Date: 1/29/2025

## Addendum #1

Project: Kitchen & Cafeteria Renovation at North Providence High School

1  
SK.A-101

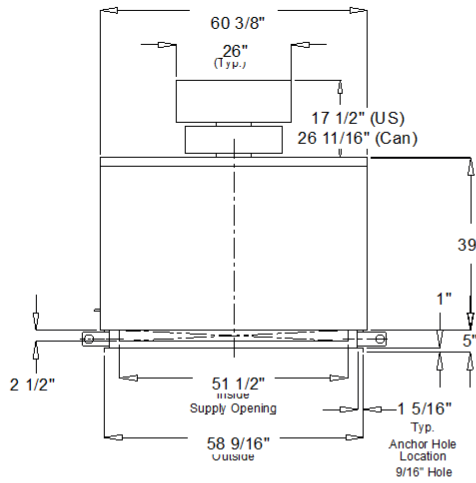
6. Existing mechanical, electrical, and/or fire alarm devices noted to remain are to be set within new ceiling systems.
7. See attached for location of existing electrical panels.

Job Name: NPSD- 2024  
 Project Name:  
 Unit Name: GRAA  
 Result Name: Kitchen MUA

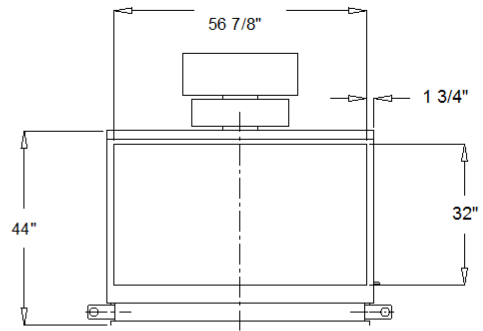
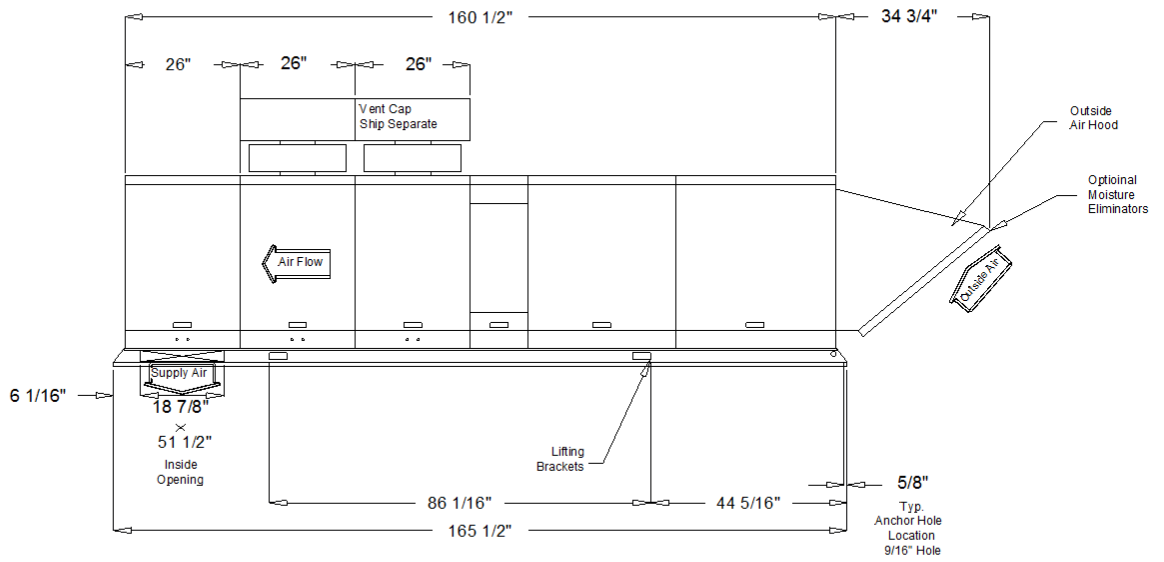
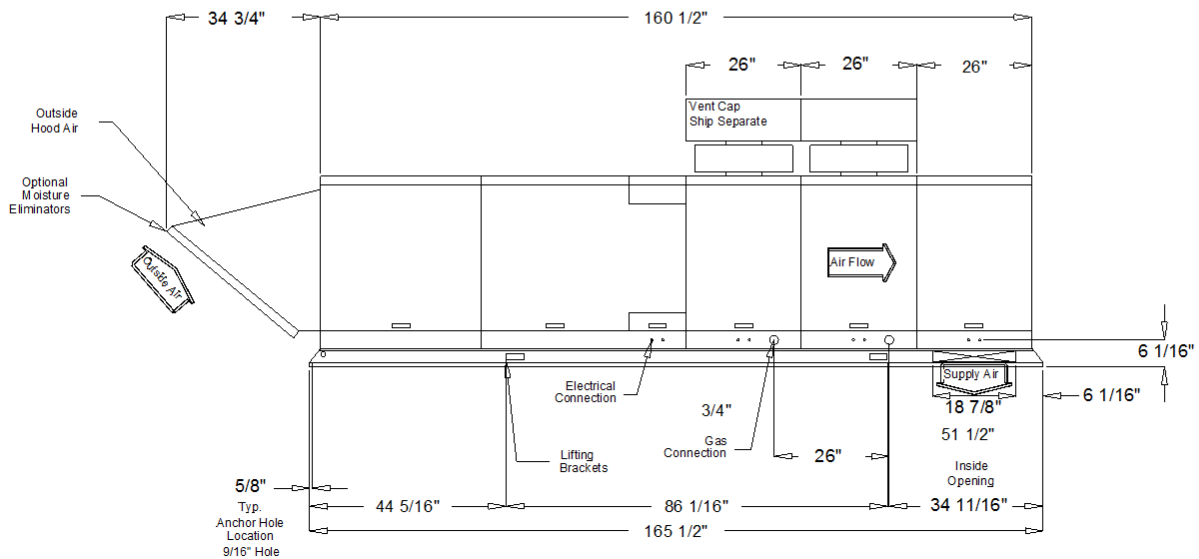
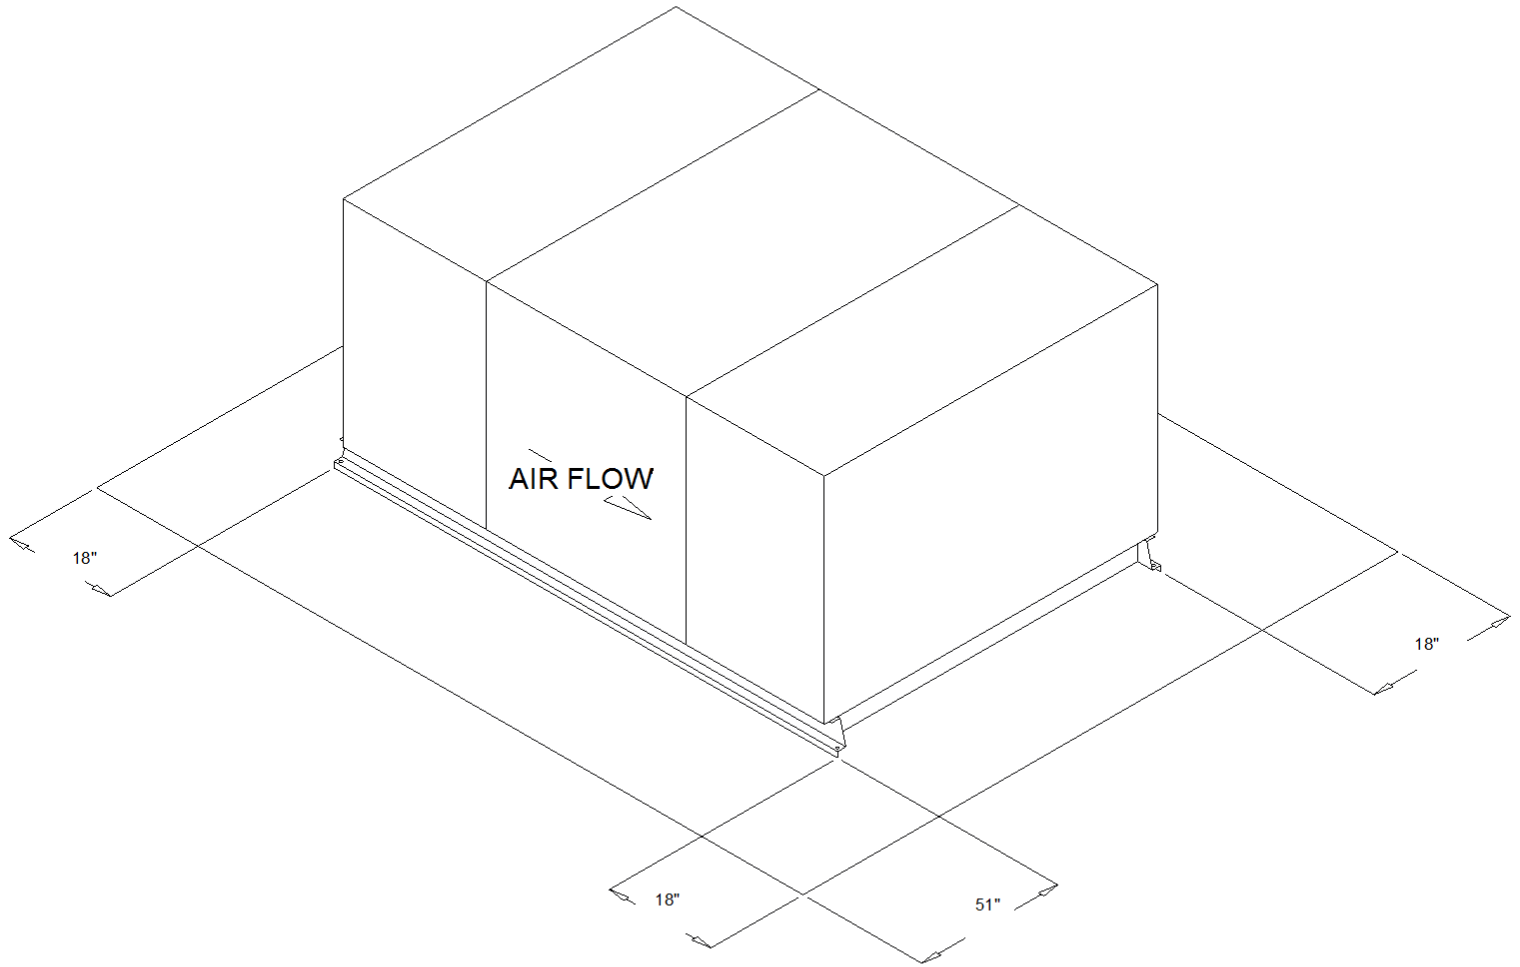
- b) Demolish electrical disconnect, wiring, and breaker back to source panel located in the kitchen.
  - c) Disconnect and reconnect gas piping.
  - d) Furnish and install new MAU. See attached cut sheet.
